Porsche Carrera Cup France 2024

Note Technique 13/2024

AUTOCOLLANT BONBONNE D'EXTINCTEUR

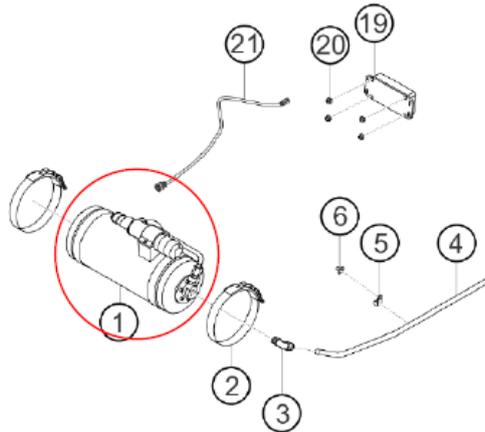
Porsche Motorsport vous informe que pour toutes les Porsche 911 GT3 Cup (type 992), les bonbonnes du système d'extincteur devront être équipées d'un nouvel autocollant mentionnant l'extension d'homologation du système d'extincteur, lors de leur prochaine révision.

Les autocollants actuels indiquent la mention « Classe 1 », qui autorise les voitures de compétition à être utilisées avec des carburants sans éthanol.

Le système d'extincteur de votre Porsche 911 GT3 Cup (type 992) est désormais homologué pour une utilisation avec des carburants contenant jusqu'à 30% d'éthanol, ce qui correspond à la « Classe 2 ».

Les classes seront détaillées sur les nouveaux autocollants.

La bonbonne d'extincteur doit être envoyée dans un centre de révision agréé FEV.

FIRE EXTINGUISHER BOTTLE STICKER

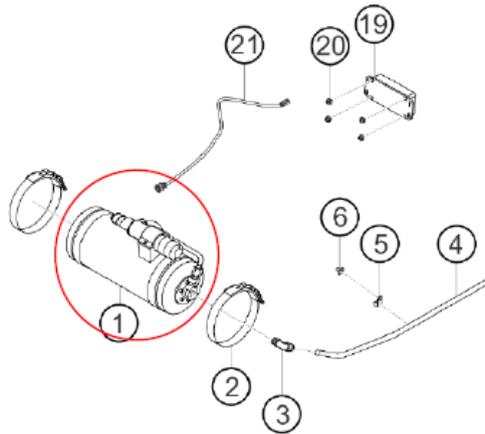
Porsche Motorsport informs that on all Porsche 911 GT3 Cup (992) vehicles, the extinguishing bottle of the fire extinguishing system must be fitted with a new sticker showing the extended homologation of the fire extinguishing system at the next manufacturer's maintenance.

The currently affixed stickers indicate "Class 1", which allows the race car to be operated with fuels without ethanol. The fire extinguishing system used in all vehicles of the above-mentioned types has now been successfully certified for operation with fuels containing up to 30% ethanol, which corresponds to "Class 2".

The classes are listed on the new sticker.

The fire extinguishing cylinder must be sent to the respective FEV service partner.
